ISSUE: Certificate of Appropriateness for alterations

LOCATION: Old and Historic Alexandria District
407 Prince Street

STAFF RECOMMENDATION

**BAR #2019-00065**
407 Prince Street

407 PRINCE ST.
FRONT STOOP W/
PROPOSED RAILINGS

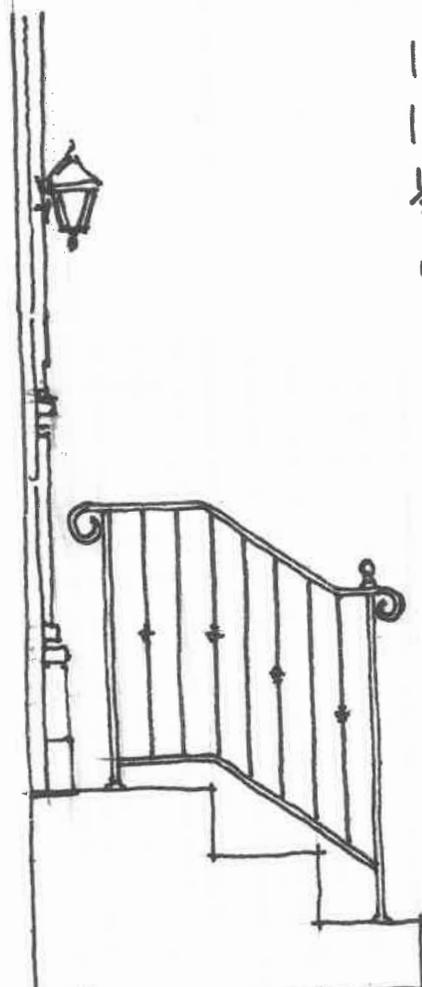
1. The railing cannot penetrate the historic stone steps and must be mounted into the sidewalk;
2. Work with staff to refine the railing design to be architecturally appropriate to the Victorian period.

In the present case, staff has no objection to the installation of iron handrails but recommends a simpler and stylistically appropriate design consistent with the *Design Guidelines*, which recommend that:

Staff supports the installation of handrails in this case for safety reasons but recommends the applicant work with staff to refine the design of the proposed railing. The railing should be either a visually minimal handrail (post and rail without balusters) or an appropriate Victorian period handrail design. There are many examples of Victorian handrails in the district, including the following examples at 211 North Columbus Street and 208 South Pitt Street (Photos 5 & 6).

Finally, wherever possible iron handrails should be mounted into the sidewalk and from the building wall, rather than the brick or stone steps, to prevent damage to the historic masonry from expansion of rusting iron, as shown in Photo 9. The new guardrails currently being installed at the Carlyle House museum are stainless steel, as the base of the similar iron railings, first installed in 1975, rusted and severely damaged the stone steps on all four sides of the
